**IEEE 802.11**  
**Wireless Access Method and Physical Specification**

Title: **Analysis of OQPSK Modulation On  
DSSS PHY Acquisition**

Date: 8 November 1993

Author: Paul Struhsaker

Figure 3 DQPSK and OQPSK Recovery and Demodulation Diagram

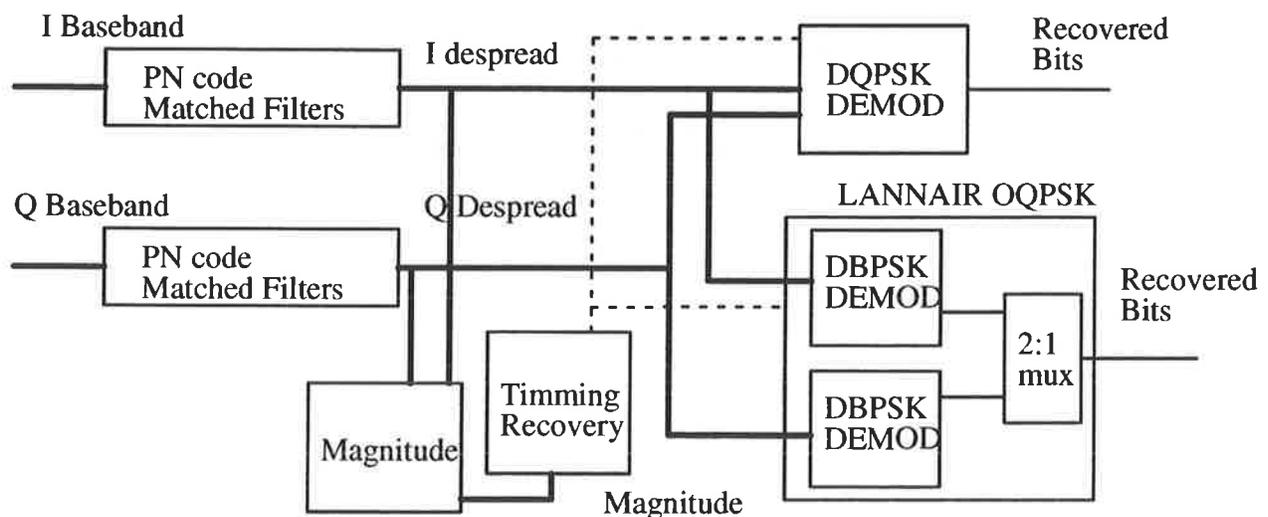
Incoherent code recovery is based on evaluating the magnitude ( $I^2 + Q^2$ ) of the received correlated signal and selecting the peak. LANNAIR proposed independent recovery of each I and Q arm as a DBPSK signal. However, until carrier recovery is completed and phase corrections are applied to force the transmitted I and Q DBPSK signal into the corresponding I and Q receiving arms, the acquisition must use a joint I and Q estimate. Figure 3 illustrates a matched filter decorrelation and demodulation for both DQPSK and OQPSK based on LANNAIR's OQPSK proposal.

There are significant differences between the recovered magnitudes for DQPSK and OQPSK. Table 1 lists these magnitude properties. Figure 4 illustrates the autocorrelation magnitudes. Based on the LANNAIR detection architecture, OQPSK suffers from a **3 dB loss** of correlation power during acquisition. This is a significant loss considering that the 802.11 DS PHY 11 chip code provides only 10.4 dB of processing gain.

Figure 5 DQPSK 2000 Simulation Samples

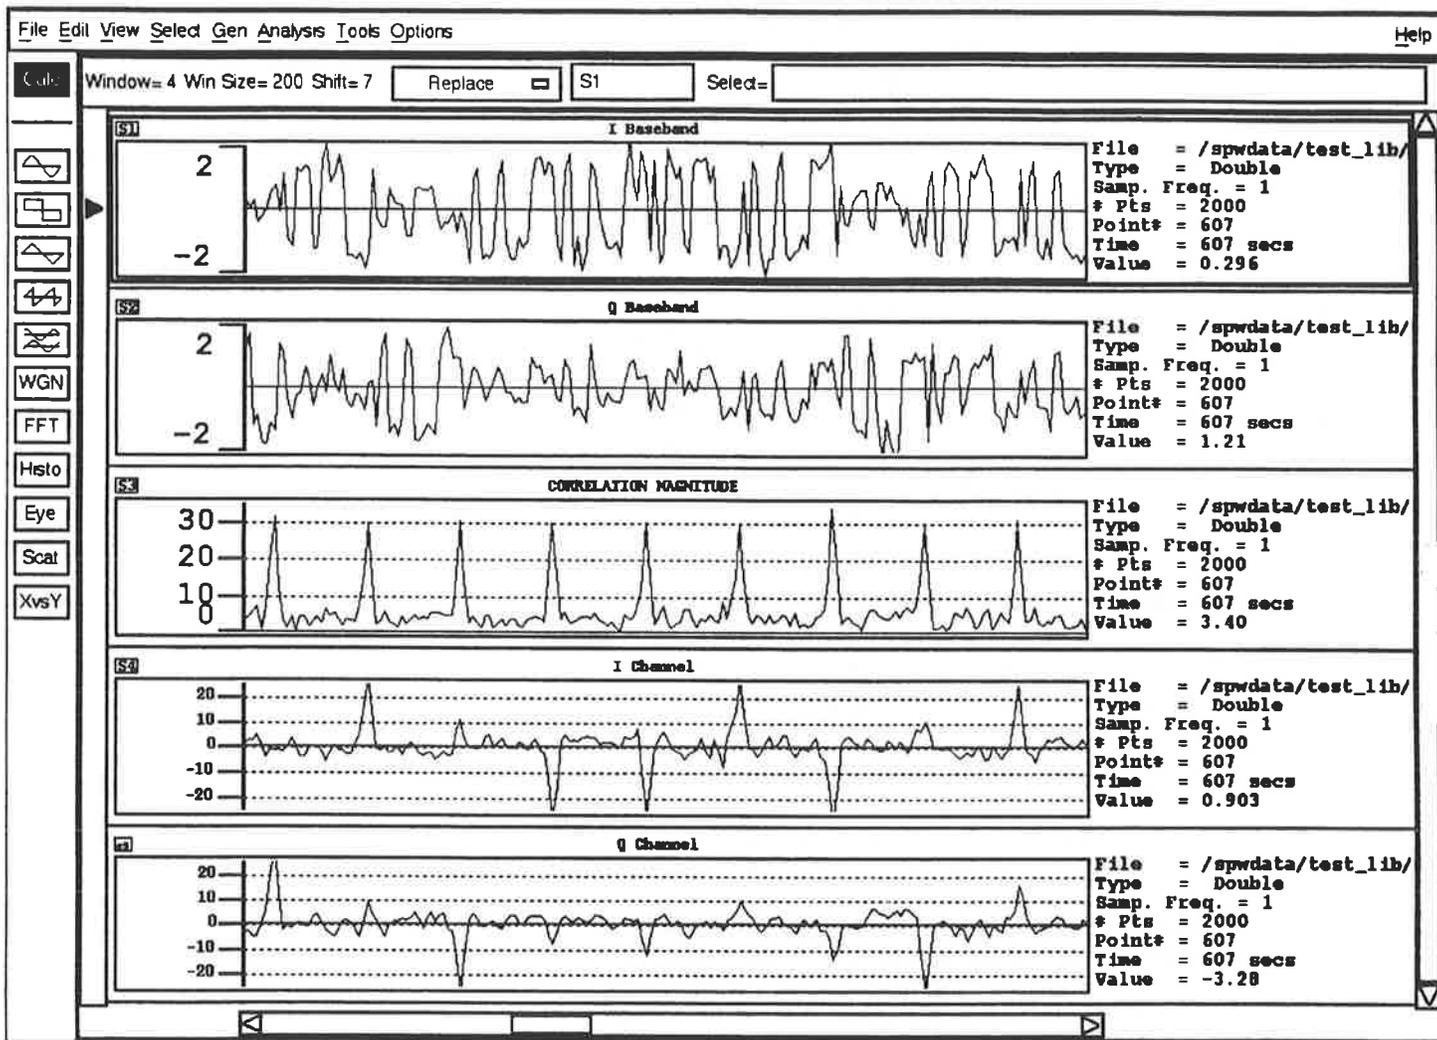
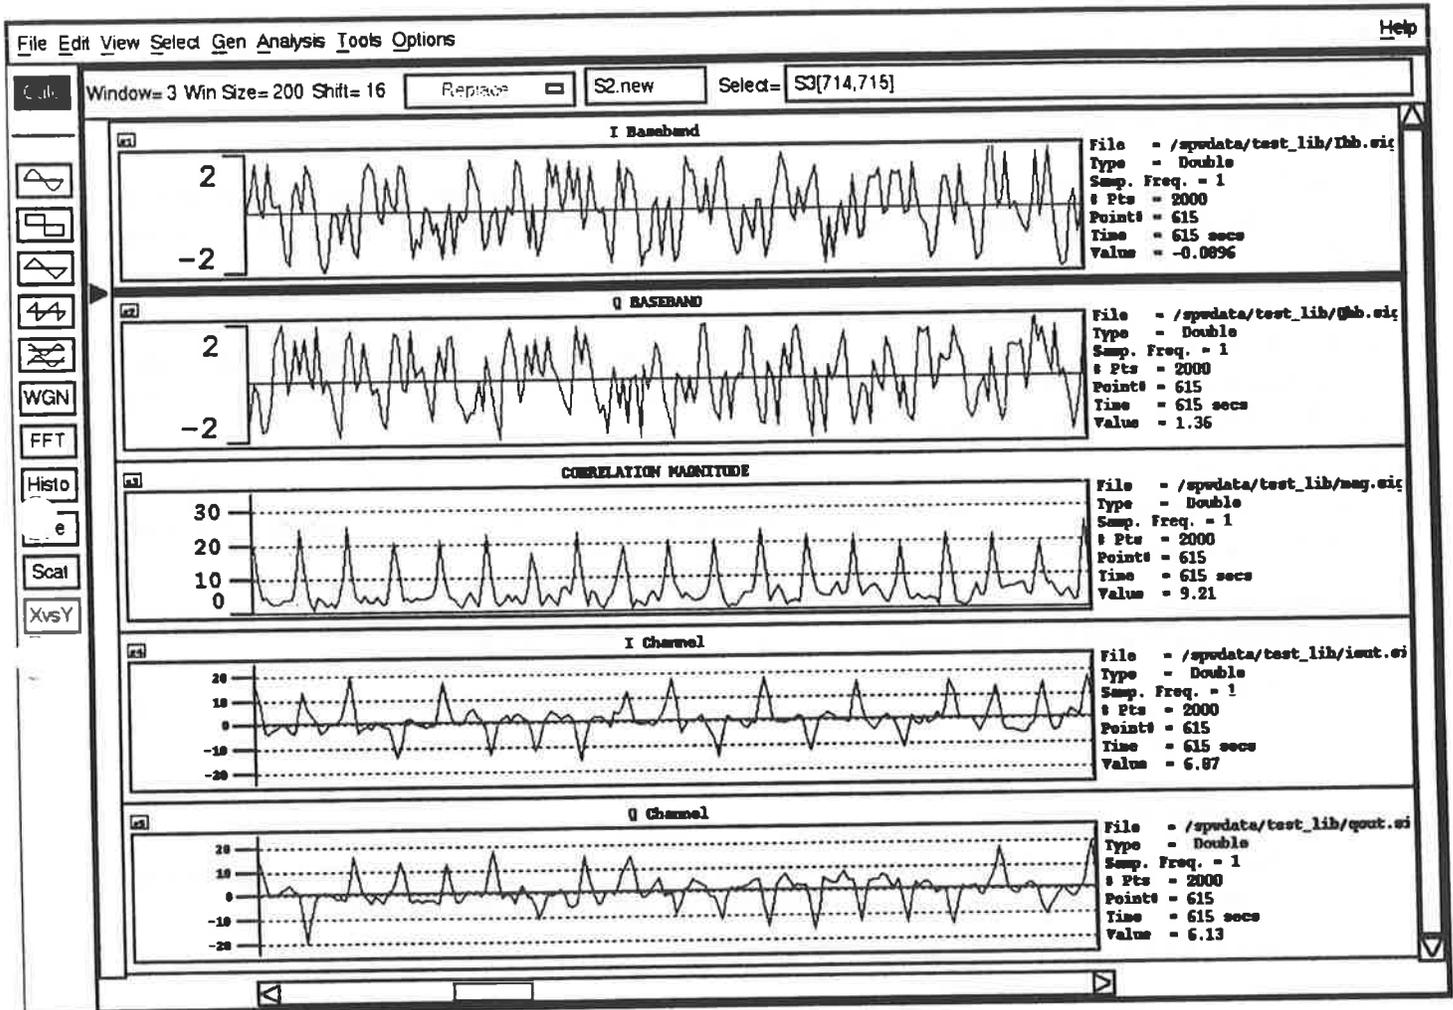
Figures 5 and 6 confirm the analysis results. OQPSK suffers a 3 dB correlation loss relative to DQPSK (or DBPSK) for incoherent code recovery. Further, it is not possible to treat the recovered OQPSK I and Q arms as independent DBPSK signals until the following conditions are met:

- Carrier lock is achieved (need a stable phase reference)
- The association of I Tx with I RX and Q TX with Q RX must be established to properly interleave the two independent bitstreams into a single bitstream to present to the MAC.
